STATE OF NORTH CAROLINA
DEPARTMENT OF TRANSPORTATION

September 30, 2025

SUBJECT: Request for Modification of the Phased Section 404 Individual Permit and Section 401 Individual Water Quality Certification for the construction of the Triangle Expressway Southeast Extension from NC-55 Bypass in Apex to I-40, Wake and Johnston Counties. TIP Nos.: R-2721, R-2828, and R-2829. Federal Aid Project No. 0540047.

We are requesting a modification to Section 404 Authorization (SAW-2019-02240) and the associated 401 Individual Water Quality Certification (Permit No. 20181249). This request is prompted by several areas changing from one wetland impact type to another (e.g. mechanized clearing to excavation) or temporary stream impacts changing to permanent stream impacts for bank stabilization purposes. Also, additional impacts are needed for a ditch tie-in at Wetland WHG, which was removed during the 4B meeting, but is being added back in as a permit site (Site 13). Details of why these changes are being made are provided below.

PERMIT DRAWING SHEET 40 OF 112

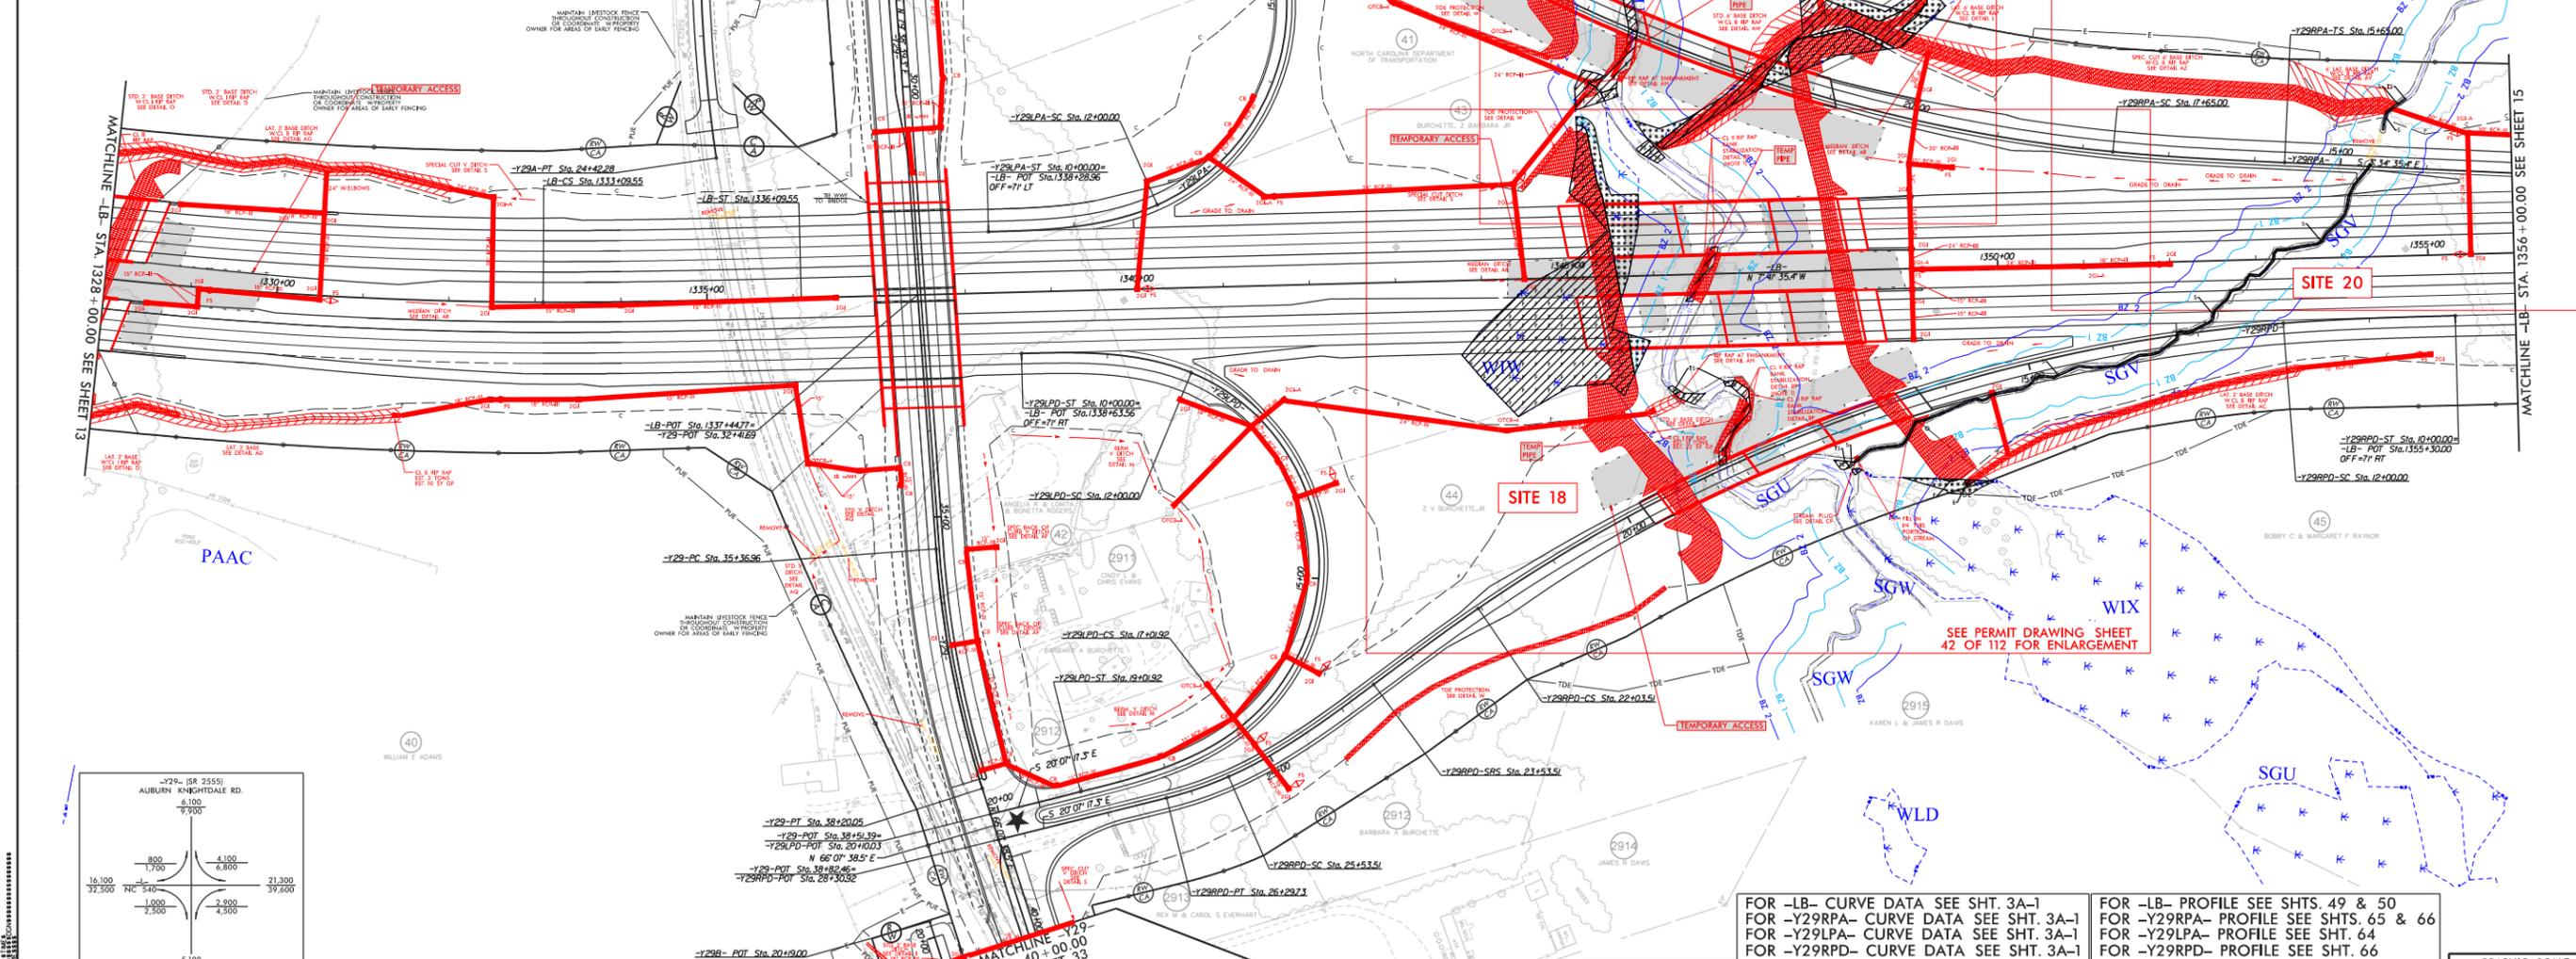
- Permanent Stream Impact (Bank Stabilization): 306 lf (previously 60) – **Increase of 246 lf**
- Temporary Stream Impact (Causeway): 73 lf (previously 285) – Decrease of 212 lf
- Temporary Stream Impact (Dewatering): 36 lf (previously 70) – Decrease of 34 lf

Several areas of Temporary Surface Water (SW) impacts have been converted to Permanent SW Impacts due to the placement of bank stabilization on the existing bank being necessary once the temporary pipes are removed from under the construction access causeways.

NOTE 1: NEED FOR BANK STABILIZATION TO BE DETERMINED UPON REMOVAL OF TEMPORARY PIPE

PERMIT DRAWING SHEET 61 OF 112

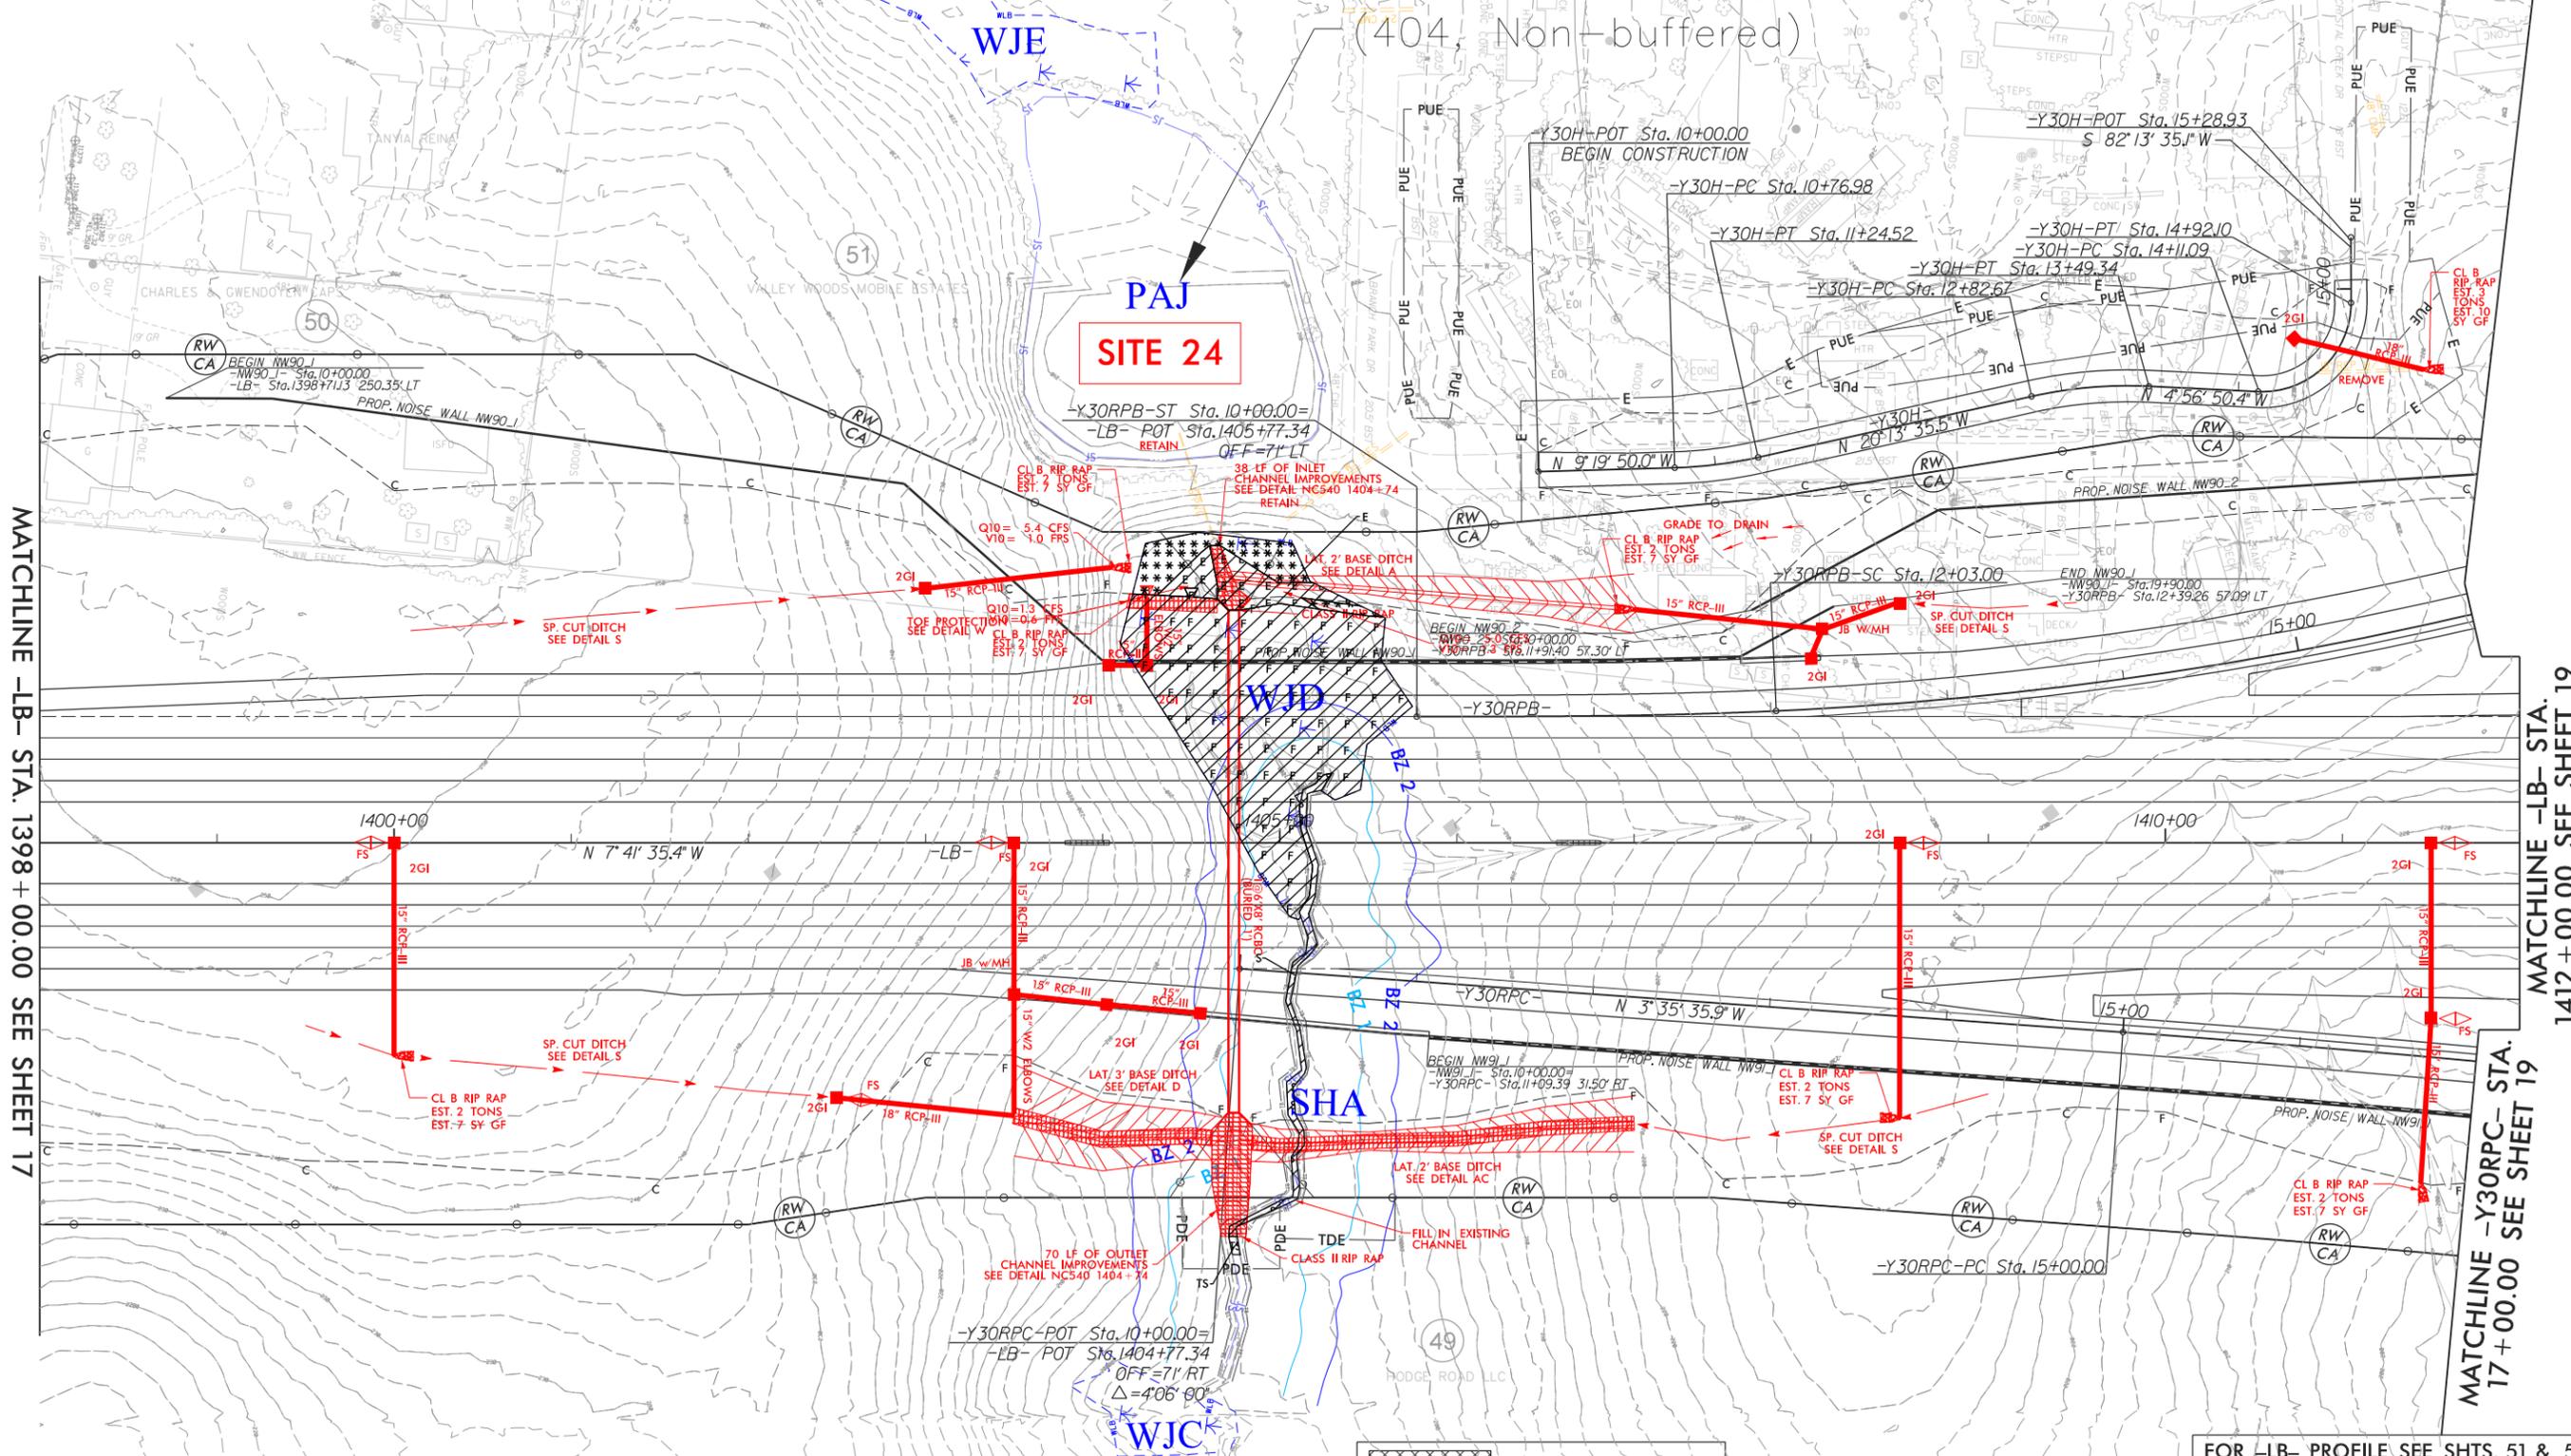
REVISIONS
8/29/2025: REVISED ROADWAY AND DRAINAGE DESIGN FOR FINAL NOISE WALL LOCATIONS.

PERMIT DRAWING
SHEET 62 OF 12

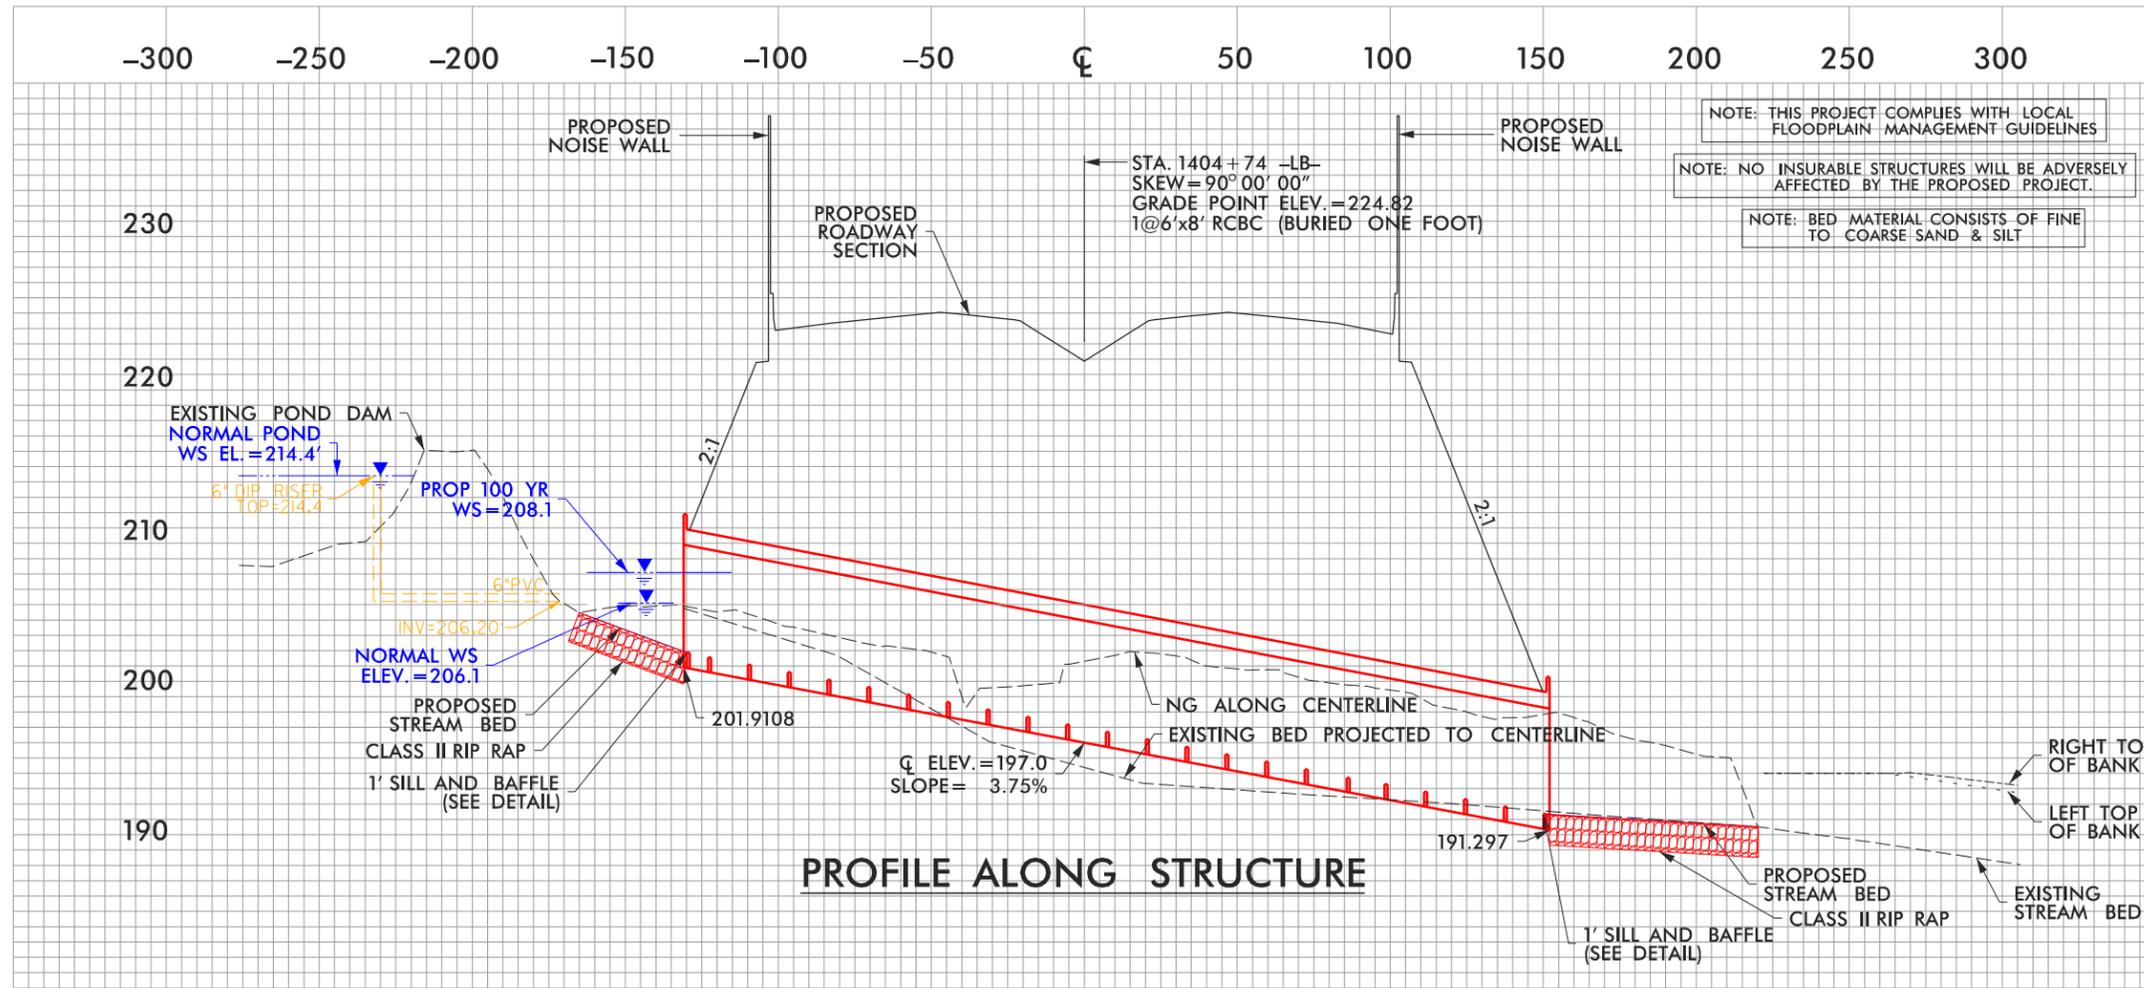
- Excavation in Wetland: 0.039 ac (previously 0.028) – Increase of 0.011 ac
- Mechanized Clearing in Wetland: 0.044 ac (previously 0.054) – Decrease of 0.010 ac
- Total Mitigable Impacts: 0.440 ac (previously 0.439) – overall **Increase of 0.001 ac**

A small area of Mechanized Clearing in Wetlands has been modified to Excavation in Wetlands. The planned temporary diversion has been adjusted to tie in on the opposite side of the culvert as originally planned, resulting in an additional 0.001 ac of Excavation in Wetlands. The grade on the north side of the culvert is better suited for a temporary diversion as proposed to mitigate potential sediment loss risks, improve erosion control, and maintenance. The existing excavation impact limits have been retained to facilitate pipe outlet grading to the culvert.

SITE 24
